SUNDRY NOTICES AND REPORTS ON WELLS CONSERVATION
Do not use this form for proposals to drill or log an oil well or an abandoned well. Use form 3160-3 (APD) for such proposals.

8. Well Name and No.
MARQUARDT 12 PENN FED 2

9. API Well No.
30-015-34329-00-C1

**** BLM REVISED ** BLM REVISED ** BLM REVISED ** BLM REVISED ** BLM REVISED ****

Cimarex Energy Co. of Colorado
 Marquardt 12 Penn Federal #2
 2310' FNL & 1330' FEL
 Sec. 12, T-25-S, R-26-E, Eddy Co., NM
 API #30-015-34329
 S. Gengler 07/15/2019

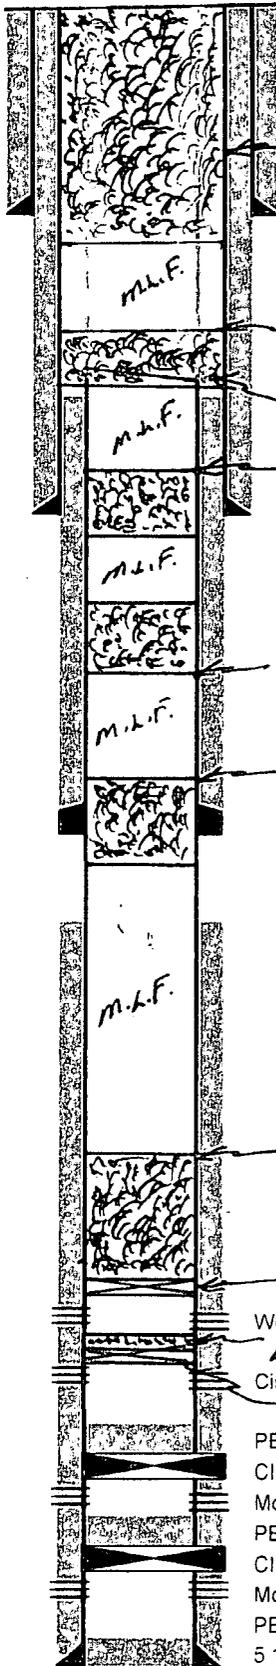
* Add Plug 850-750 WOC Tag.
